**Petition Number:** 1401-DP-02 & 1401-SIT-01

**Subject Site Address:** 945 Tournament Trail; Northeast Corner of SR32 and Wheeler Road

**Petitioner:** McDonald's USA, LLC

**Request:** Petitioner requests Development Plan and Site Plan review for a McDonald's drive-thru structure on approximately 1.1 acres.

Figure 16.04.065.K

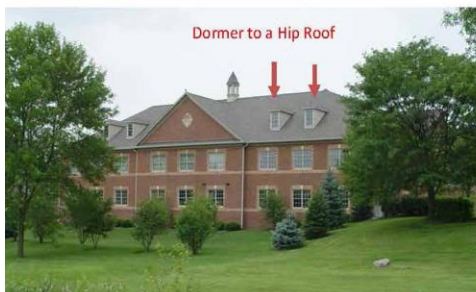
Brick and stone window surrounds were raised above the parapet (the "Towers") to address the concerns raised by the APC of the flat roof line look. In addition, the rear elevation was enhanced with a stone Tower feature.

"Modulation of the roofs and/or roof lines shall be required in order to eliminate the appearance of box-shaped buildings (see Figure 16.04.065.K)."

When the 32 Overlay was drafted, figures were included in the ordinance to further clarify the standard as envisioned. Figure K provides two examples of modulation that were envisioned.

Staff suggests that this item has been adequately resolved and complies with the standard. At the previous APC meeting, the APC requested that the Petitioner revise its elevations in a manner that would provide more of a landmark or “wow” factor effect.
